Metro North-West Joint Development Assessment Panel Agenda

Meeting Date and Time: 1 April 2020; 09:00am
Meeting Number: MNWJDAP/283
Meeting Venue: This meeting is available for members of the public to attend via teleconference.

DAP Name:	Metro North-West JDAP
Local Government Area:	City of Stirling
Applicant:	Urbis Pty Ltd
Owner:	ALDI Foods Pty Ltd
Value of Development:	\$4.5 million <input type="checkbox"/> Mandatory (Regulation 5) <input checked="" type="checkbox"/> Opt In (Regulation 6)
Responsible Authority:	City of Stirling
Authorising Officer:	Stevan Rodic, Acting Director Planning and Development
LG Reference:	DA19/1926
DAP File No:	DAP/19/01711
Application Received Date:	9 December 2019
Report Due Date:	20 March 2020
Application Statutory Process Timeframe:	90 Days
Attachments:	<ol style="list-style-type: none"> 1. Development plans date stamped 20 December 2019 and 28 February 2020 2. Aerial Location Plan 3. Metropolitan Region Scheme Zoning Map 4. City of Stirling Local Planning Scheme Zoning Map 5. Turning movement diagrams date stamped 28 February 2020 6. Applicants Response to City's Design Review Panel held 23 January 2020 received 28 February 2020 7. Applicants re

t16.099B.sk29d
27/02/2020
Scale: 1:400 @ A3

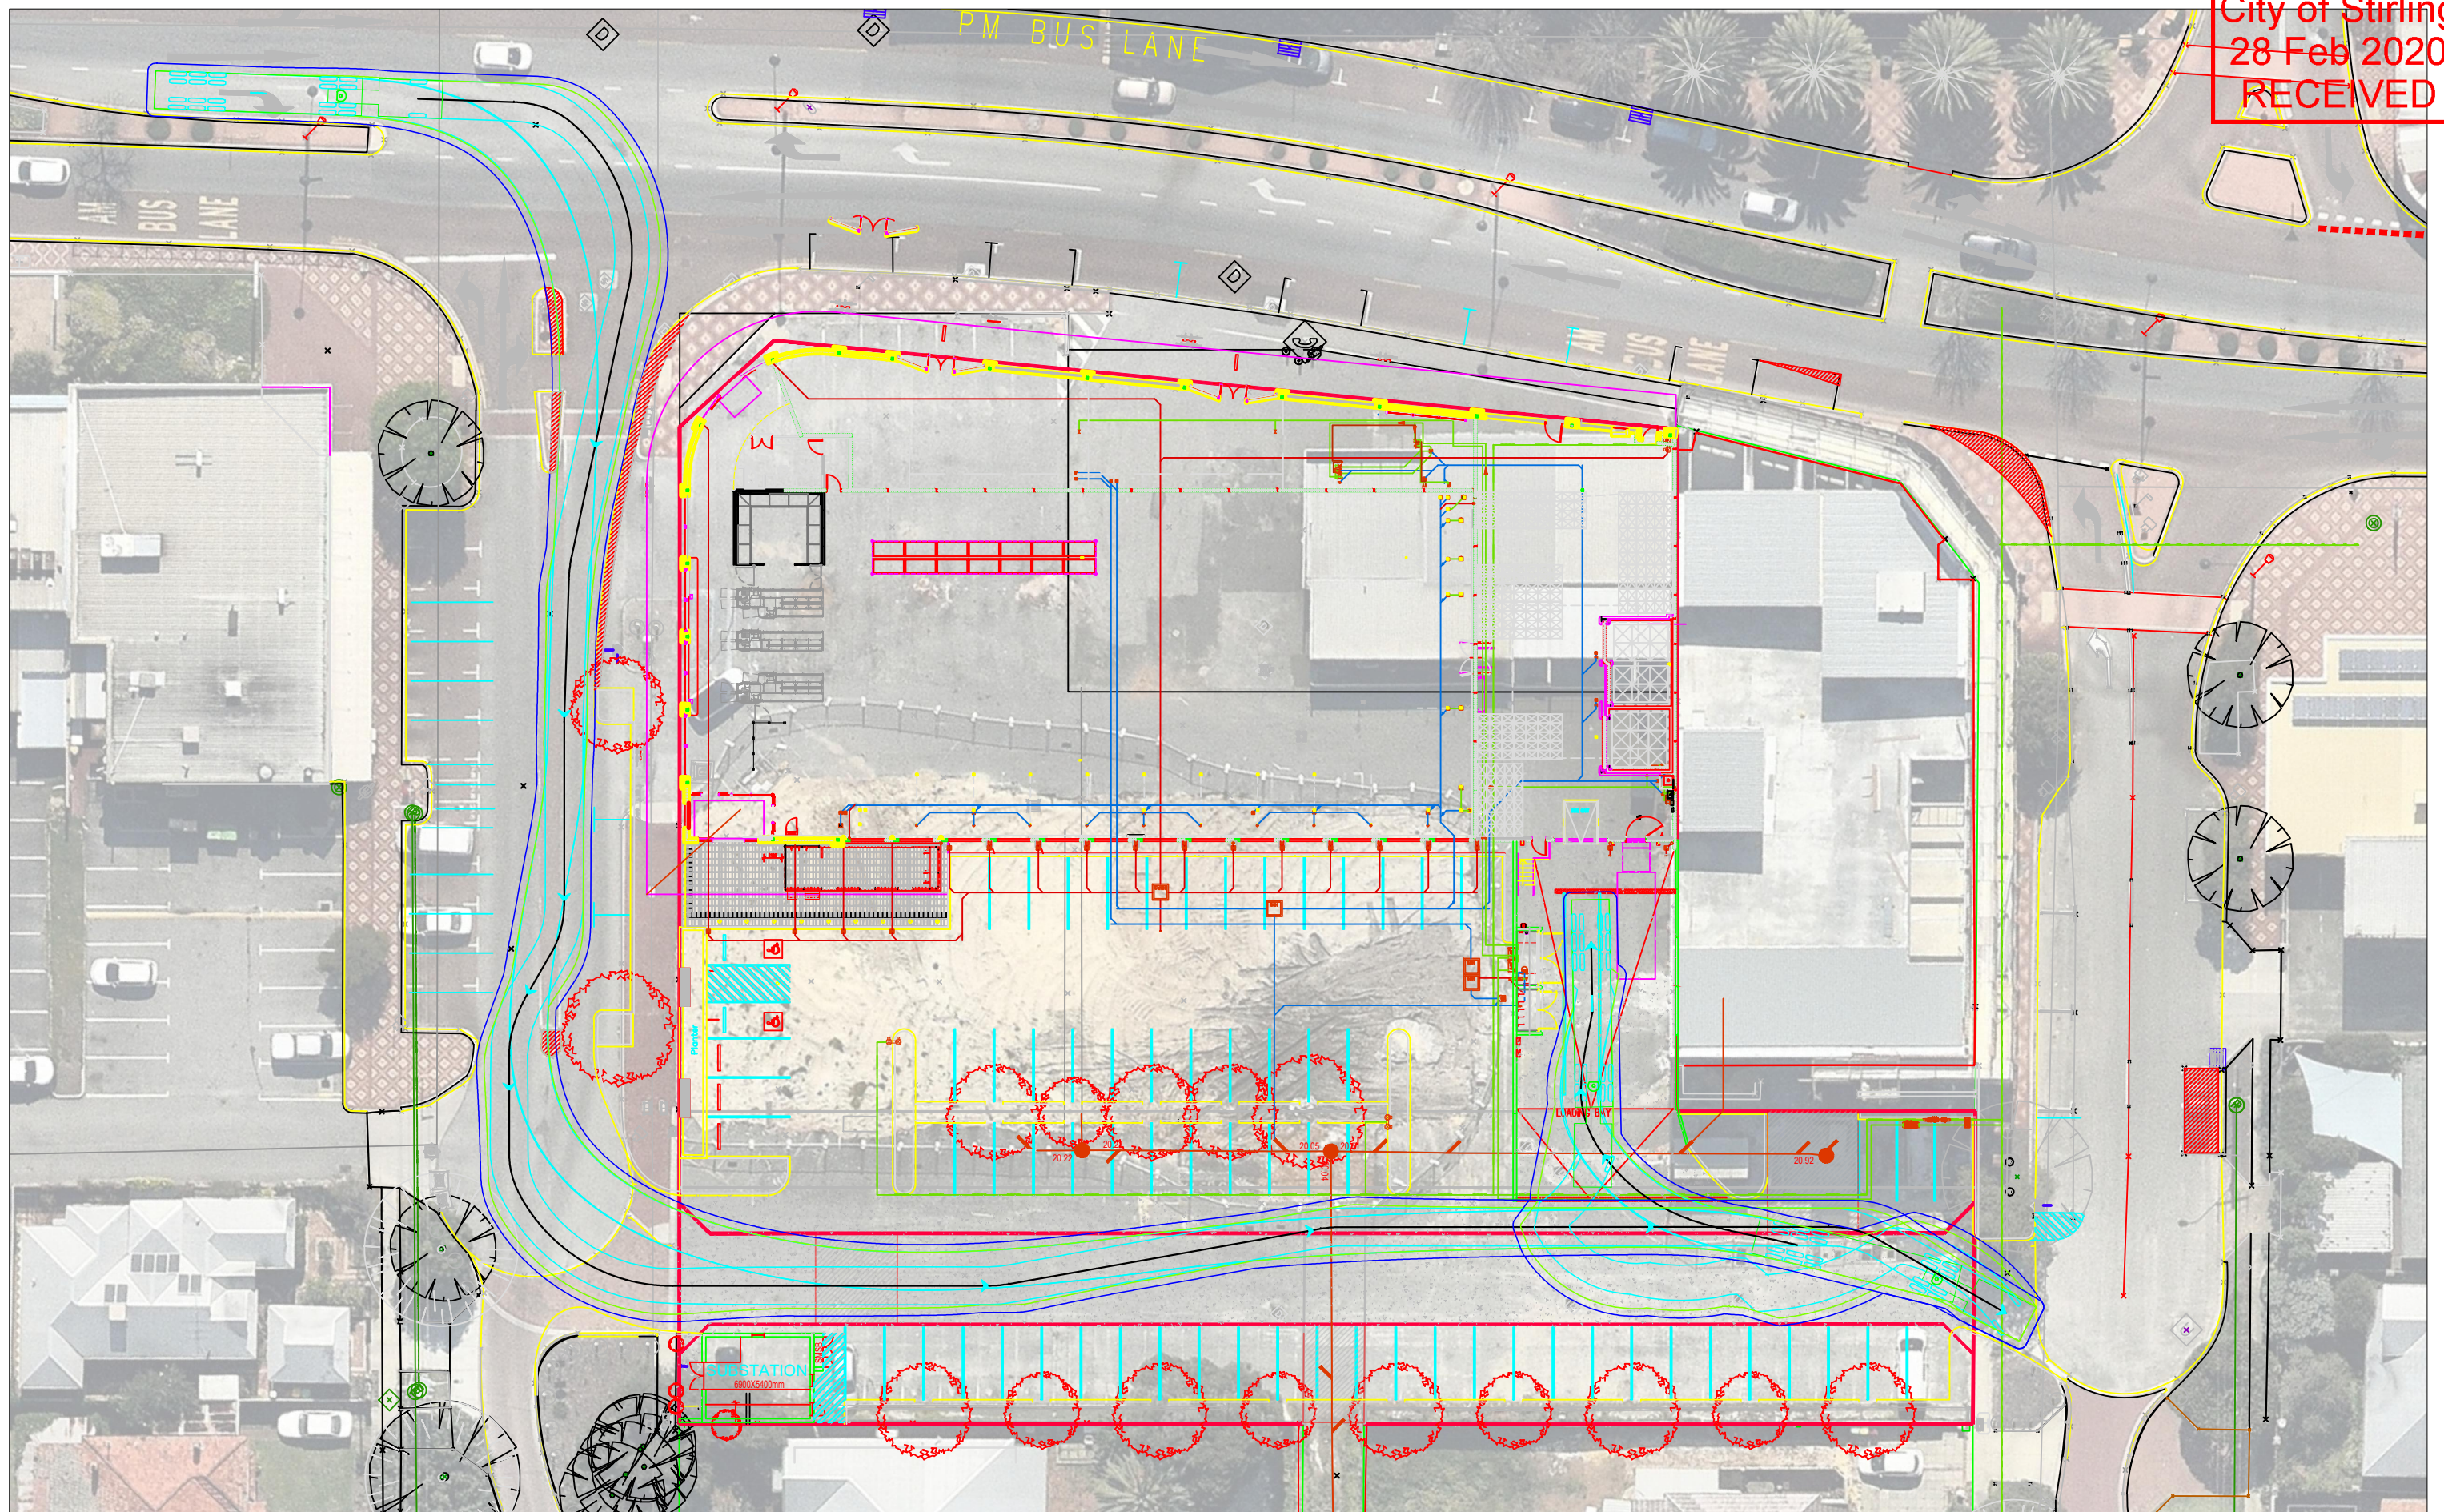
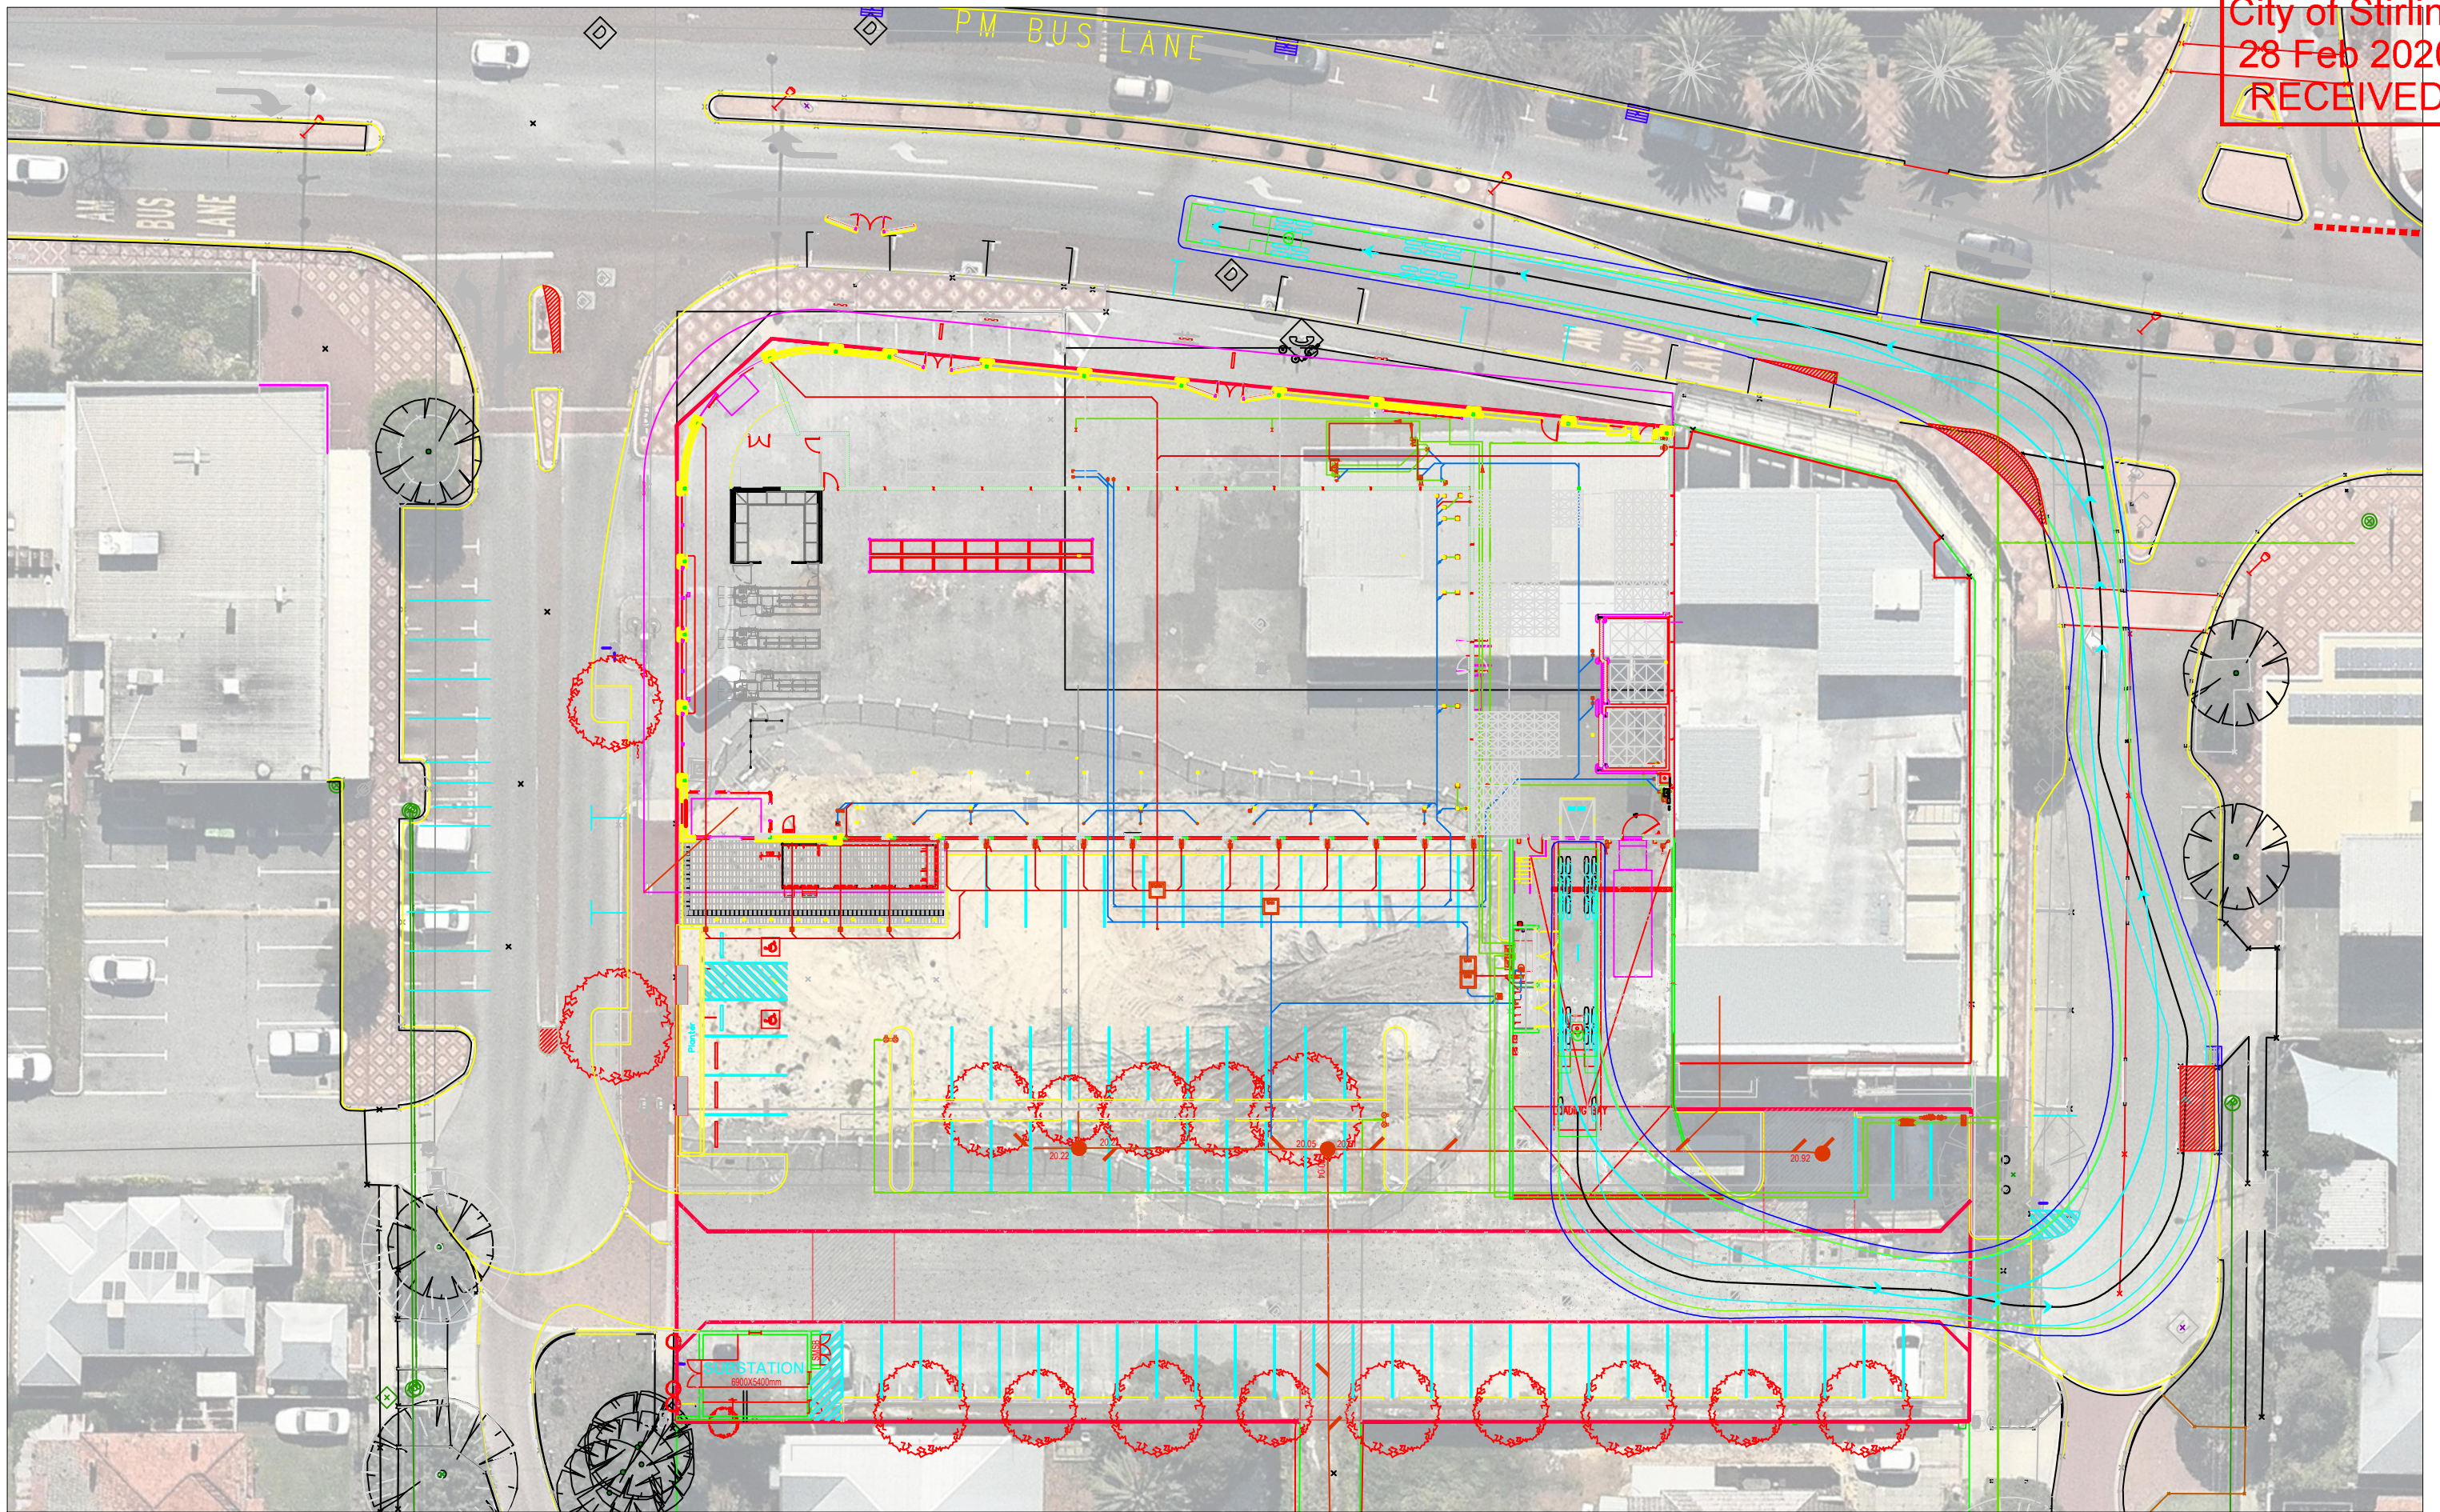
- Provides an assessment of the proposed development access points;
 - Models the site utilising the current traffic data;
 - The 19.0m Semi-trailer Truck Circulation Diagrams t16.099B.sk29d and t16.099B.sk30c are to remove the requirement for modification to the existing Beaufort Street/Tenth Avenue and Beaufort Street/Eleventh Avenue intersections;
